2.2 Control and Instrument Systems

The information in this section of the reference ABWR DCD, including all subsections, tables, and figures, is incorporated by reference with the following departures.

Figure 2.2.1 Rod Control and Information System Control Interface Diagram

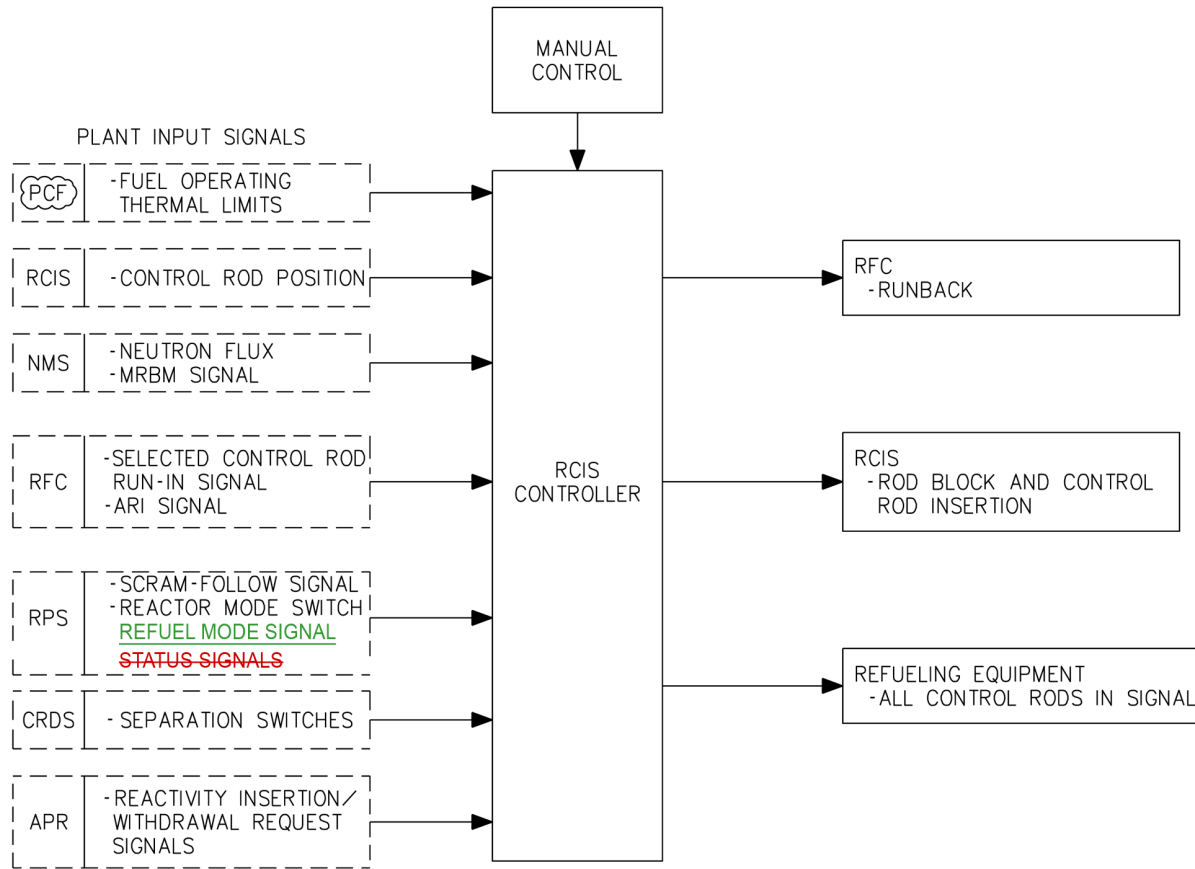
STD DEP T1 2.2-1 (~~Figure 2.2.1—RPS~~, ~~Table 2.2-12.2.1—Item 811~~)

STD DEP T1 3.4-1 (Figure 2.2.1—PCF)

NOTE:
1. INTERCONNECTIONS MAY BE FIBER-OPTIC OR METALLIC.

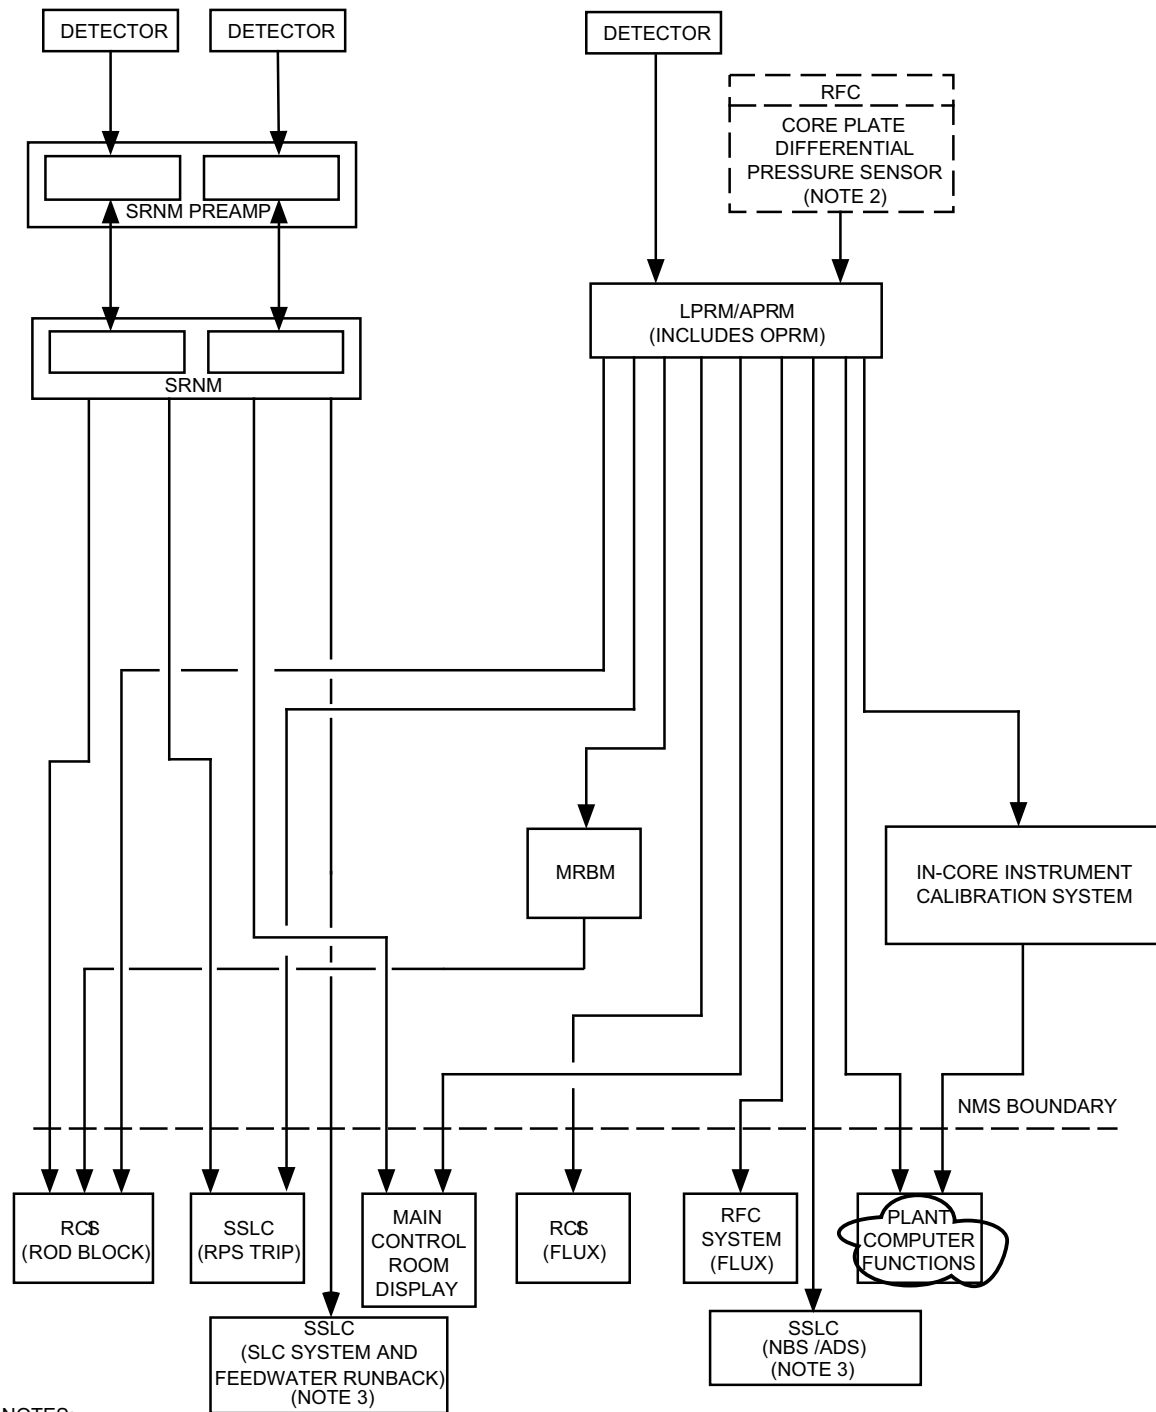
The FDWC digital controllers determine narrow range level signal using three reactor level measurement inputs from the NBS. ~~Sensor signals are transmitted to the FDWC digital controllers by the Non-Essential Multiplexing System (NEMS).~~

The steam flow in each of four main steamlines is sensed at the RPV nozzle venturis. ~~Sensor signals are transmitted to the FDWC System digital controllers by the NEMS.~~ These measurements are processed in the digital controllers to calculate the total steam flow out of the vessel.

Feedwater flow is sensed at a flow element in each of the two feedwater lines. ~~Sensor signals are transmitted to the FDWC digital controllers by the NEMS.~~ These measurements are processed in the digital controllers to calculate the total feedwater flow into the vessel.

Figure 2.2.6 Remote Shutdown System

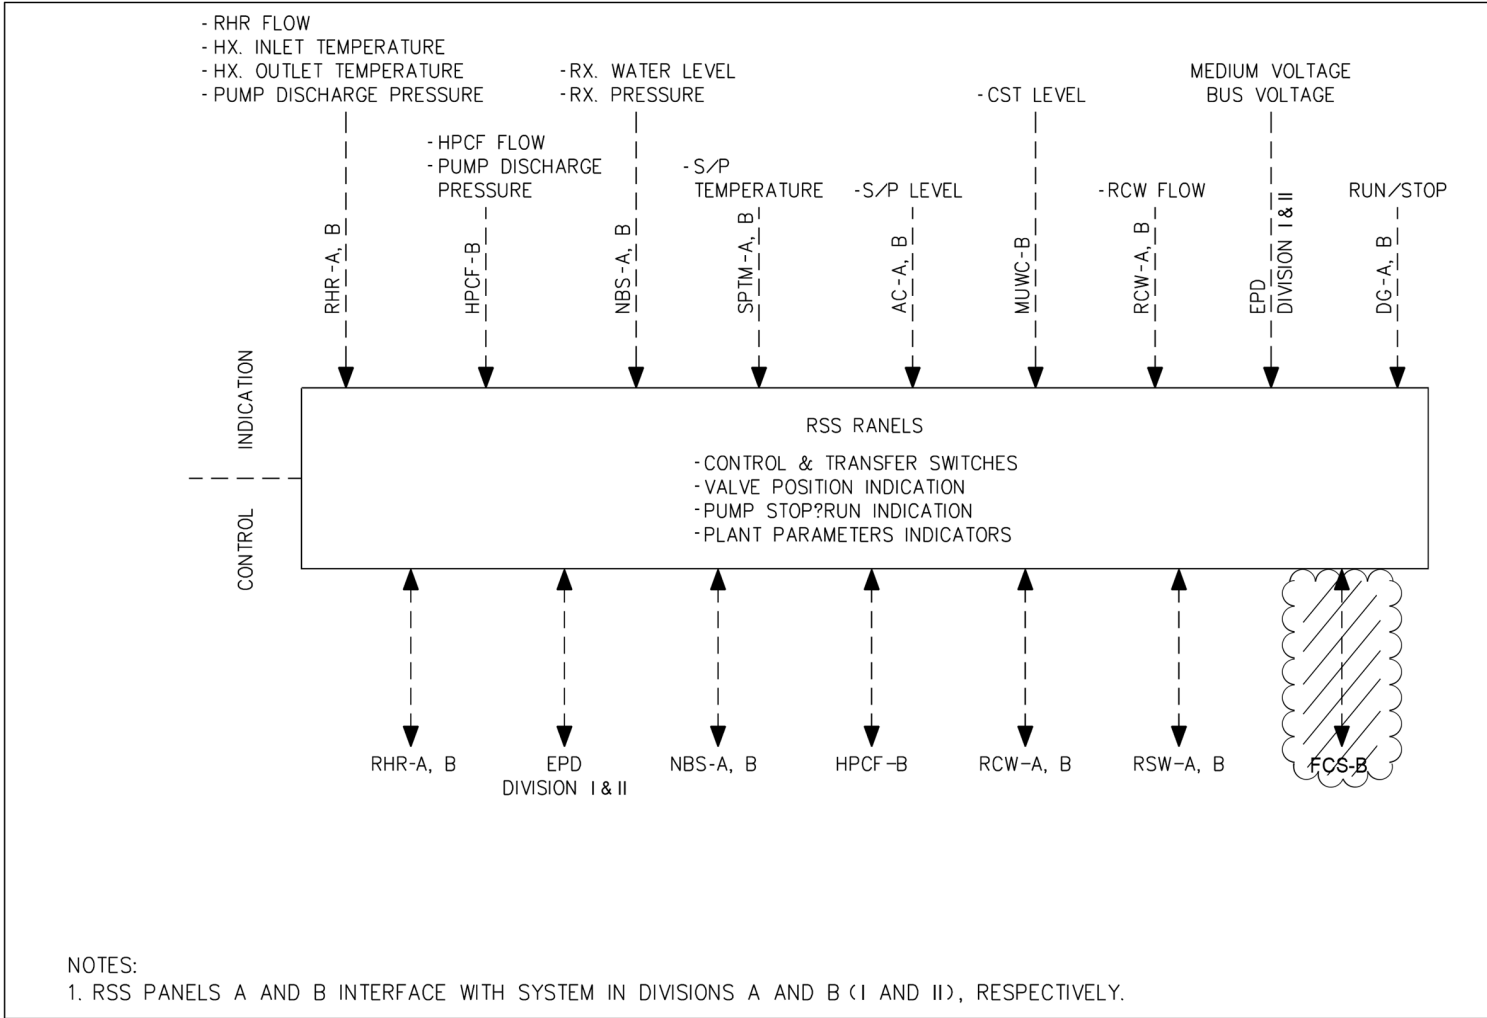
STD DEP T1 2.14-1 (Figure 2.2.6)

(10) ~~Flammability Control System (FCS)~~ Not used

Figure 2.2.7b Reactor Protection System

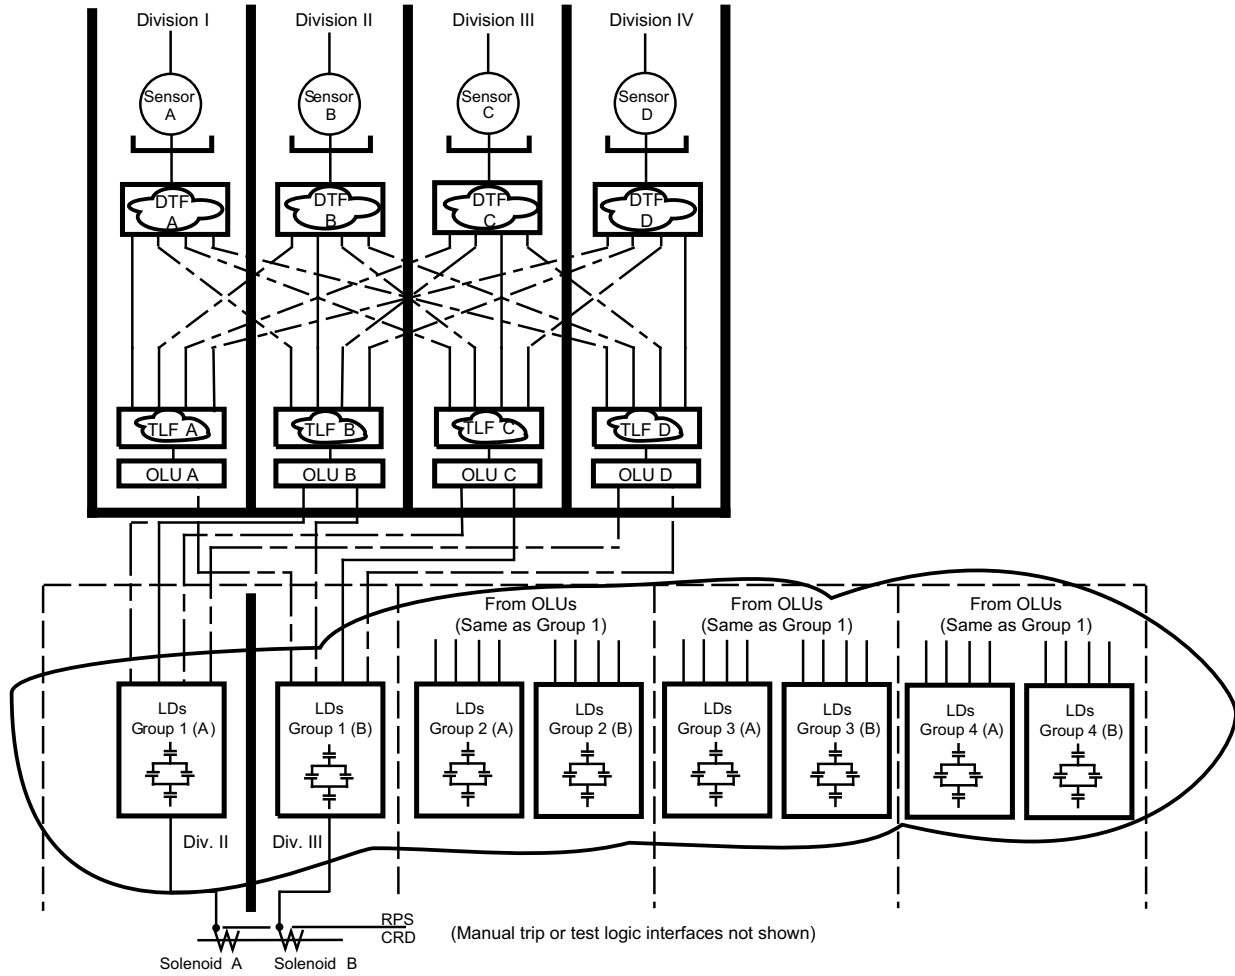
STD DEP T1 3.4-1 (Figure 2.2.7b)
